Addendum No. 1

**CDBG-MIT GLO CONTRACT NO. 22-085-009-D237
(CITY OF KINGSVILLE BID NO. 25-20)
CITY OF KINGSVILLE GLO SW PROJECT 1 (E. SANTA GERTRUDIS ST.) STORM WATER
IMPROVEMENTS**

**TRENCH BACKFILL FOR
STORM WATER R.C. BOX CULVERTS**

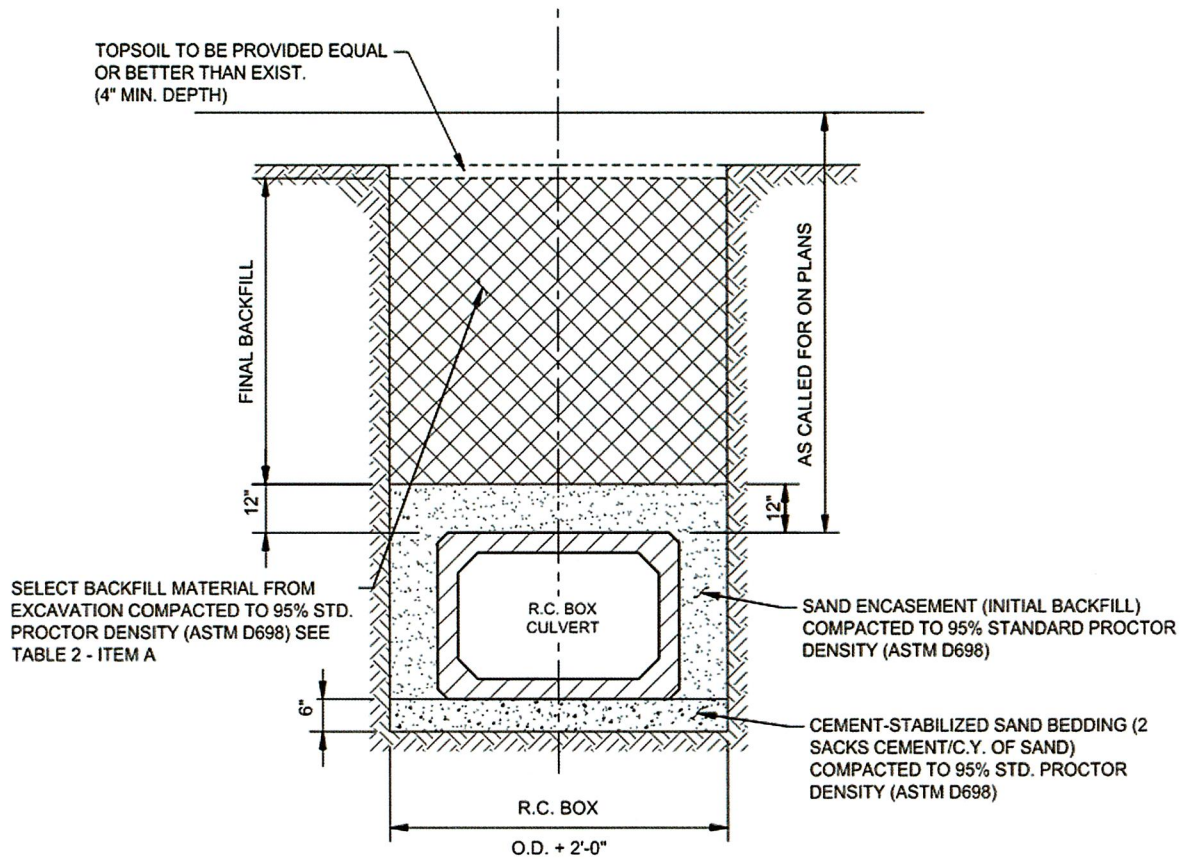
- I. Added “Trench Backfill for Storm Water R.C. Box Culverts” detail for 4’ x 3’ concrete box construction as shown on **pg. 2** of this Addendum No. 1.
- II. No partial bids shall be submitted for Base Bids. All bidders must submitted a unit cost and total with each bid item.

NOTE: (PAVEMENT ONLY)

CONTRACTOR HAS OPTION TO USE CEMENT STABILIZED SAND OR BACKFILL WITH SELECT BACKFILL MATERIAL.
